SEQUOIA

OUTLINE OF NEW FEATURES

The following changes are made for the new SEQUOIA.

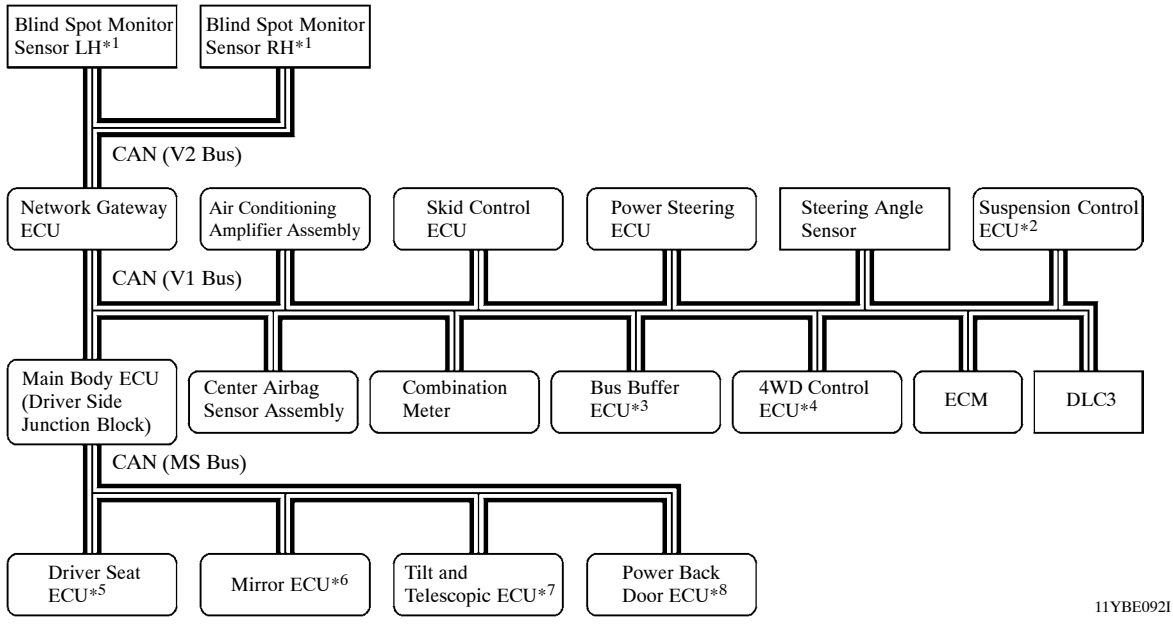
Trailer sway control is provided for the brake control system. For details, see page 5.
A TRC OFF indicator light is newly provided on the combination meter.
The operation states of the brake control functions and the indicator lights in each mode are as follows:

Item	Brake Control Function			Indicator Light	
	TRC	Auto LSD	VSC	TRC OFF 11YCH054I	18PCH003I
Normal Mode	○	—	○	Off	Off
TRC OFF Mode	—	○	○	Off	Off
Auto LSD Mode	—	○	—	Off	On
VSC OFF Mode	—	—	—	On	On
